STATE OF MAINE  
DEPARTMENT OF TRANSPORTATION  
16 STATE HOUSE STATION  
AUGUSTA, MAINE  
04333-0016

June 26, 2007  
Subject: **Gorham**  
Project No. HP-8151(200)  
Pin No. 8151.20  
**Amendment No. 1**

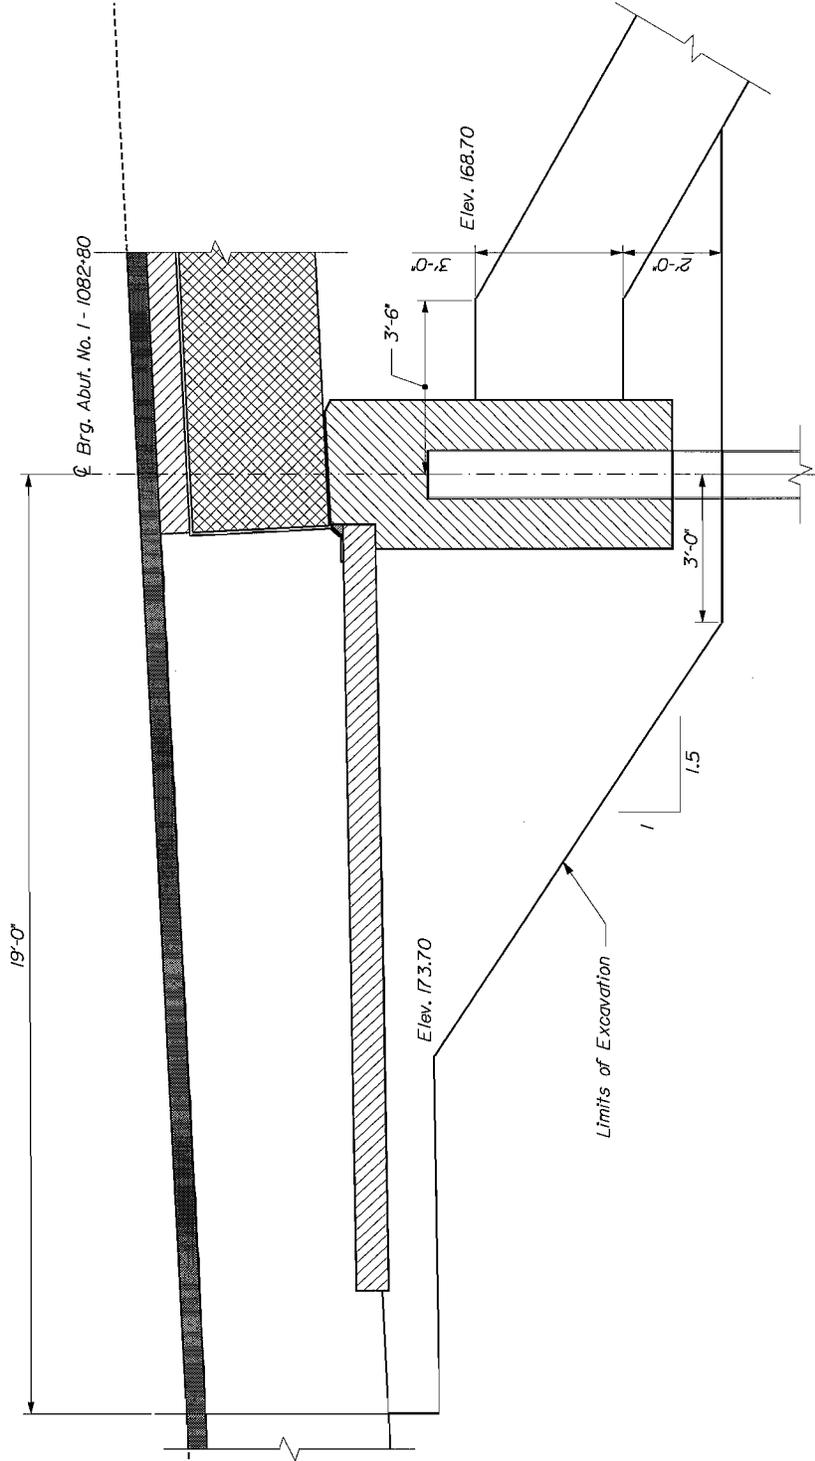
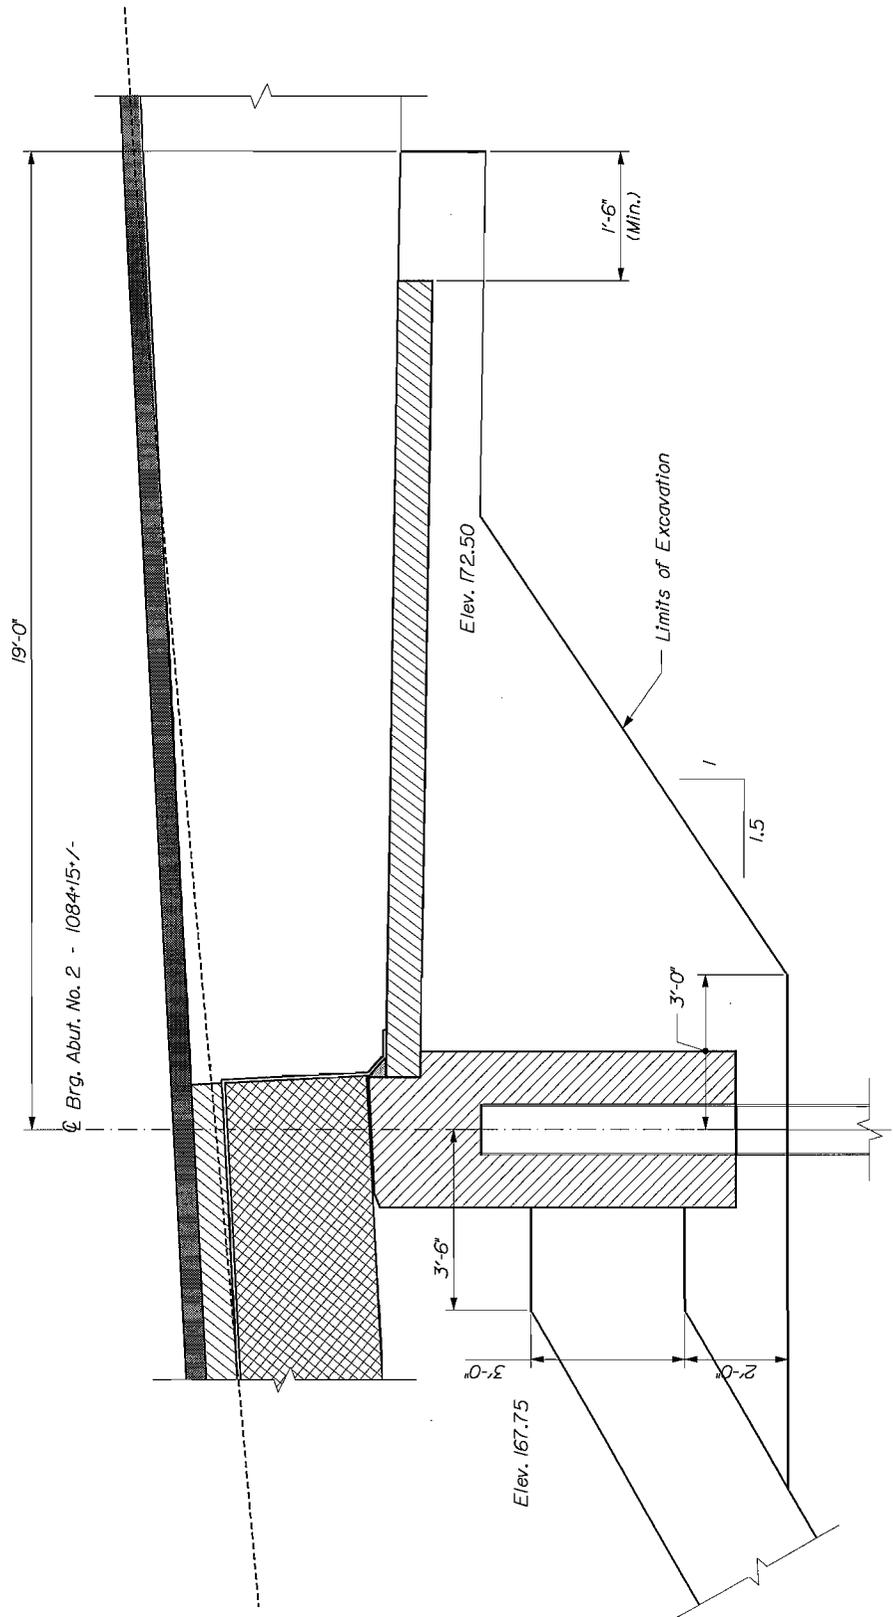
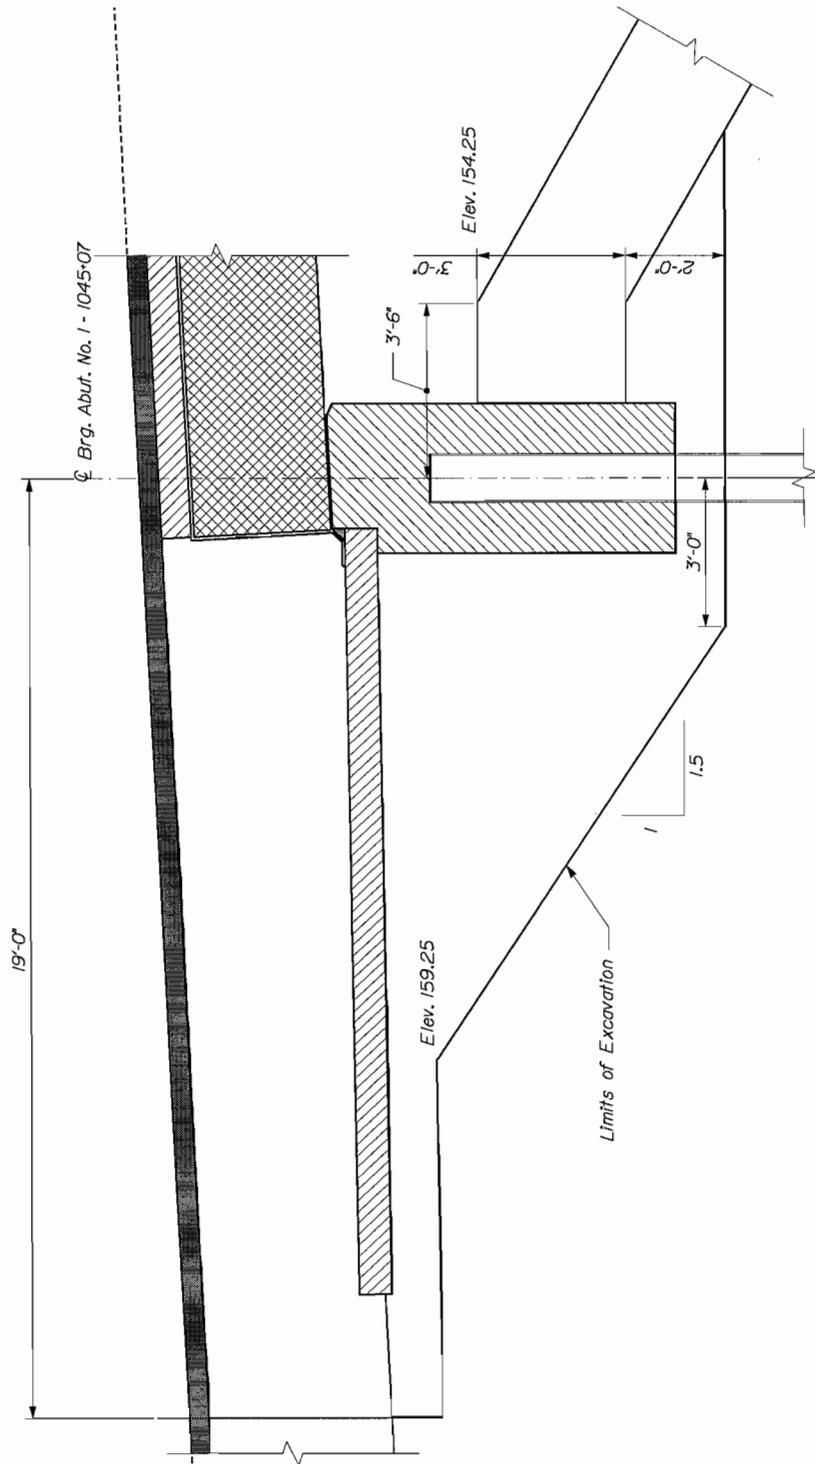
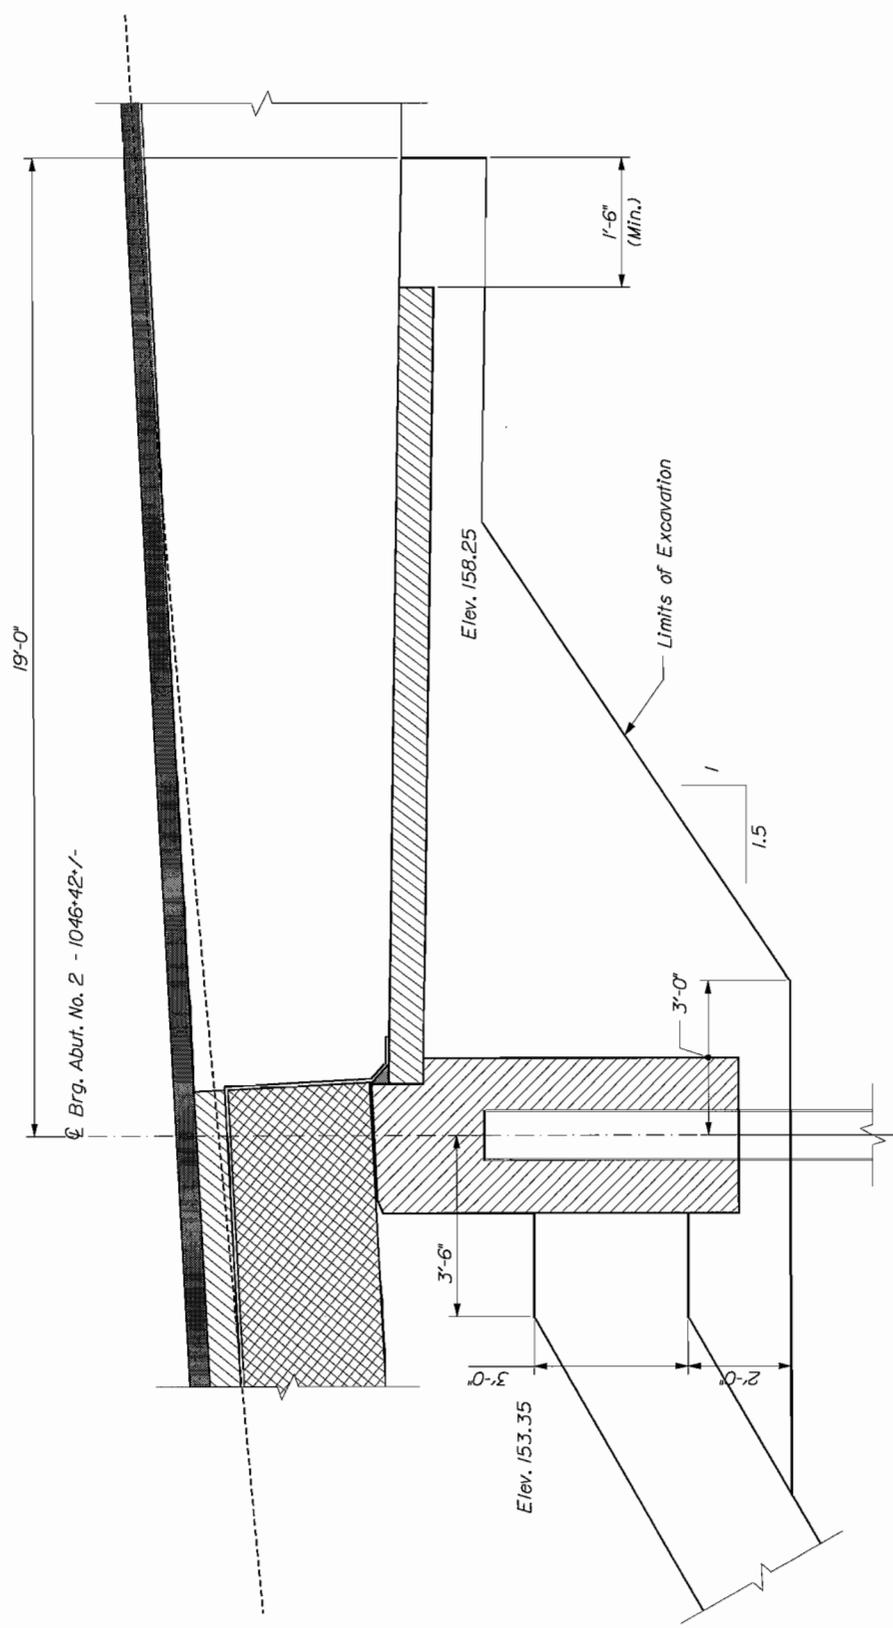
- 3.) In the Bid Book delete in their entirety the Abutment Drawings pages 62 thru 65 and replace with the new attached Abutment Drawings pages 62-A thru 65-A.

## Settlement Platform Detail

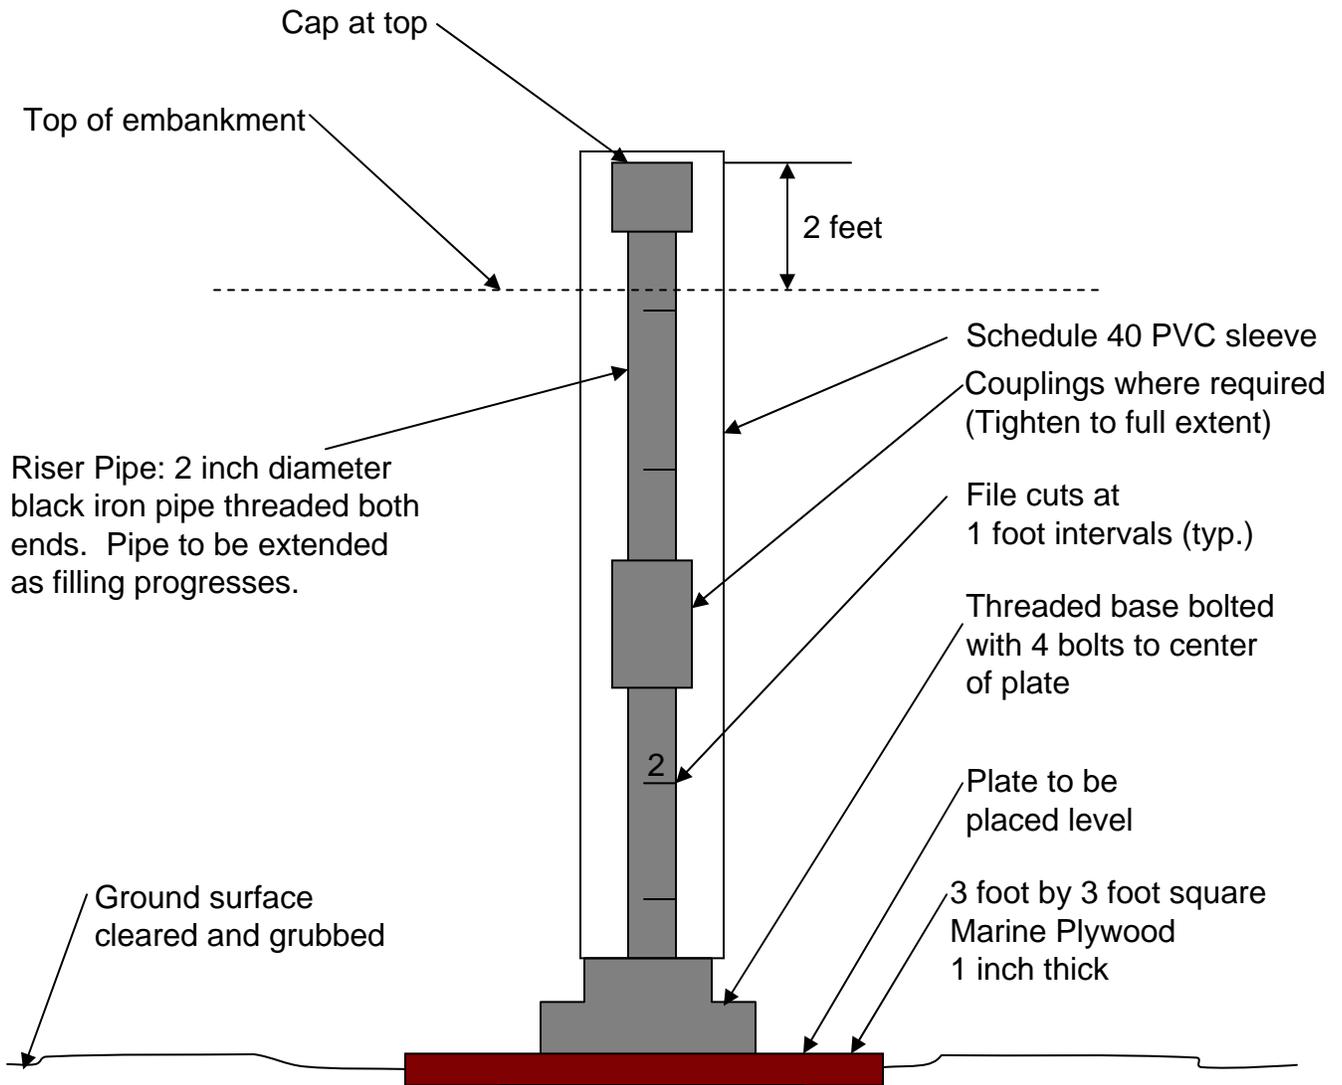
- 7.) In the Bid Book, Special Provision 639 Engineering Facilities (Geotechnical Instrumentation – Traditional Settlement Platforms) delete Detail No. 1, page 5 of 6, and replace with the new attached Detail No. 1, page 5 of 6.

**Question:** SP 639 (Traditional Settlement Platforms), on Pg. 1, materials call for 2-inch diameter black iron pipe while the detail on Pg. 5 indicates 4-inch diameter pipe. What is the correct pipe diameter?

**Response:** Page 1 calling for a 2 inch diameter black iron pipe is correct.

1. A PVC sleeve shall be placed over the riser pipe and couplings. The PVC Sleeve shall have an inside diameter 2 inches greater (minimum) than the outside diameter of the riser pipe coupling.
2. Pipe lengths shall be added as required to provide a minimum 2 foot projection over embankment at any stage of construction. A minimum 2 foot projection above the top of the completed embankment is required. A maximum pipe length of 5 feet is allowed.
